## Historic Landmarks and Preservation Districts Commission

### Report to the Committee

**Case No:** 22-COA-0112  
**Classification:** Committee Review

**Property Address:** 141 Pope Street

West Elevation 1<sup>st</sup> level new front facing windows

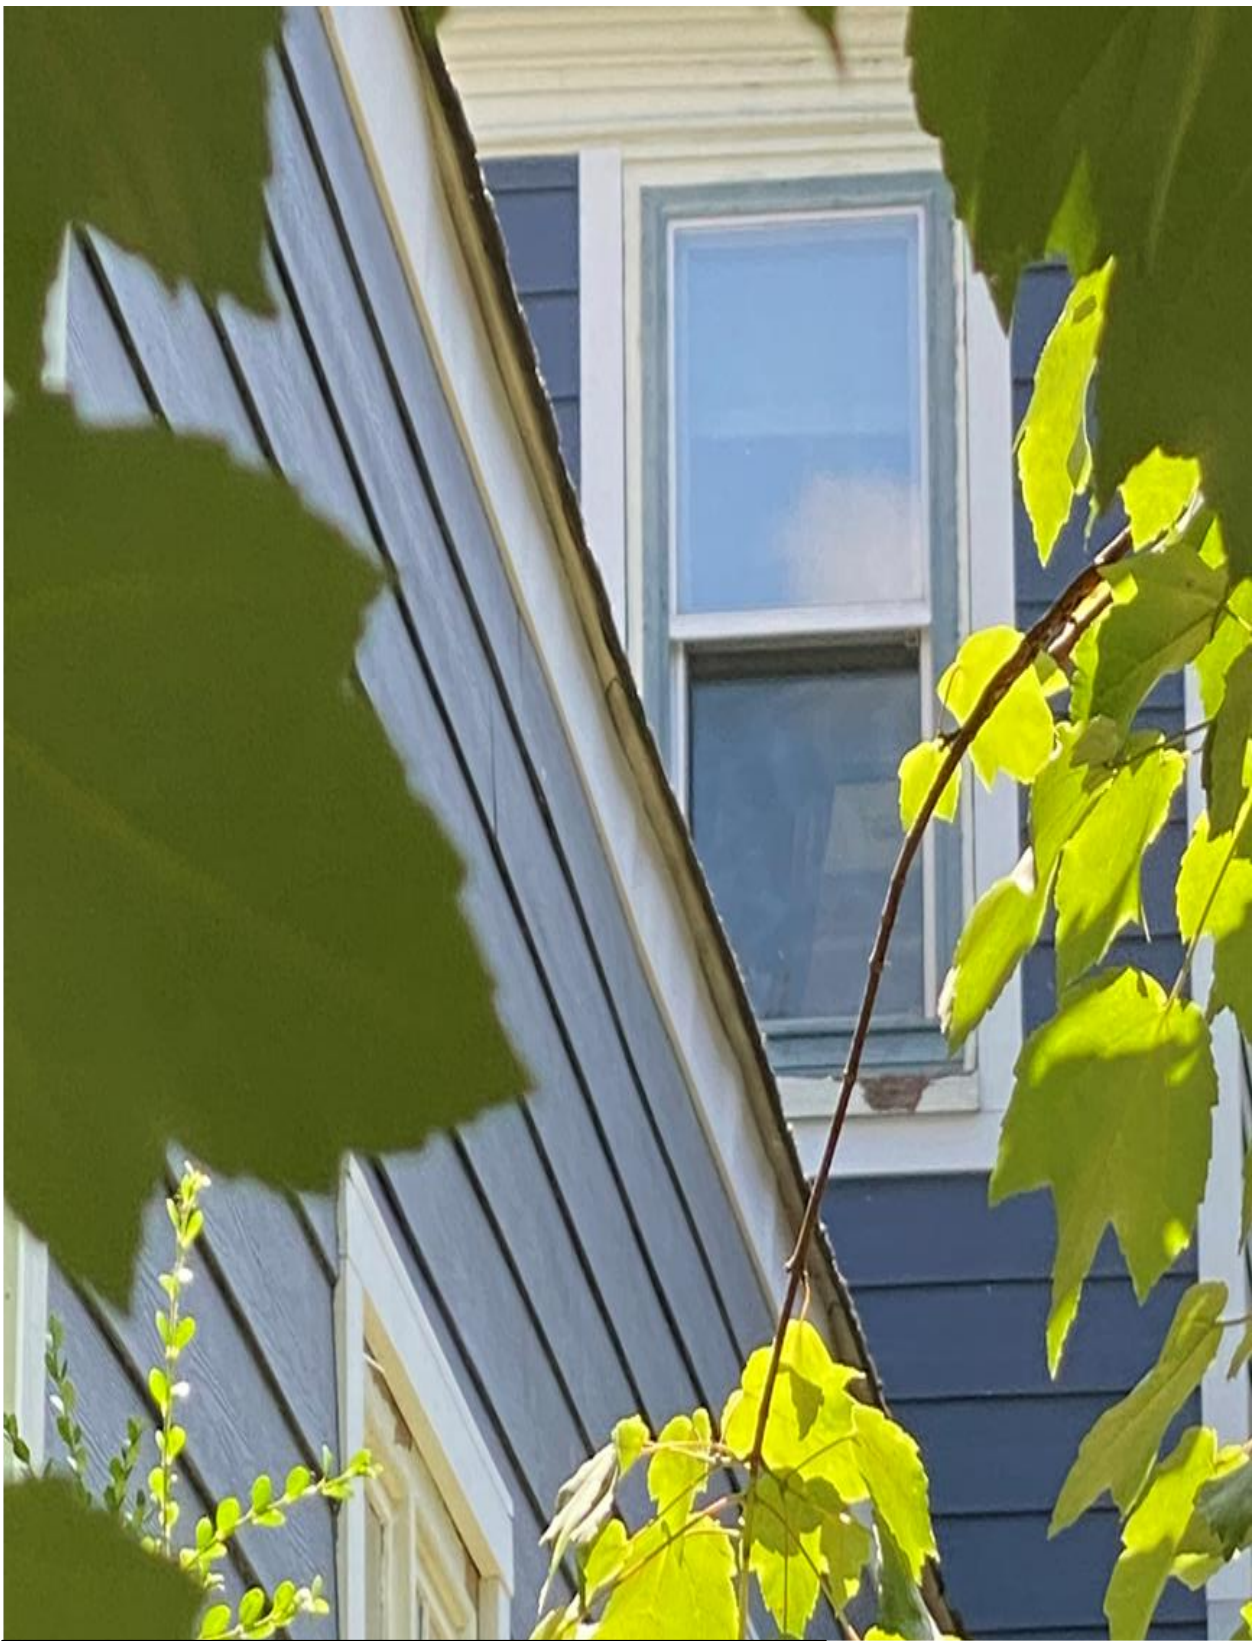
The proposed after-the-fact front facing windows generally do not meet the Clifton design guidelines for **Window**. Two of the three after-the-fact replacement windows no longer have the same one-over-one muntin pattern as the original windows did. They are now six-over-six, which does not meet W1 or W2. All three after-the-fact windows have been replaced with United 9600 Series vinyl composite replacement windows. Vinyl windows do not have the same profiles or dimensions as historic wood windows. While the design guidelines allow for synthetic, they do still have to match the historic windows. Staff recommends a different material than vinyl for the front window replacement. Furthermore, the windows should be replaced with new ones that are one-over-one to match the historic configuration.

1. The three after-the-fact replacement windows shall be replaced with one-over-one replacement windows that closely match the dimensions of the historic wood windows.
2. The replacement windows for the two front facing second-story windows shall be one-over-one and shall closely match the dimensions of the historic wood windows..
3. All glass shall be clear and non-reflective.
4. The applicant shall not wrap the window trim or sills with vinyl or aluminum.
5. The applicant shall take precautions to preserve any existing wood elements to be reapplied to the building and shall submit photographs of all elements proposed to be reconstructed.
6. The applicant shall take appropriate precautions with the handling of potential lead paint.
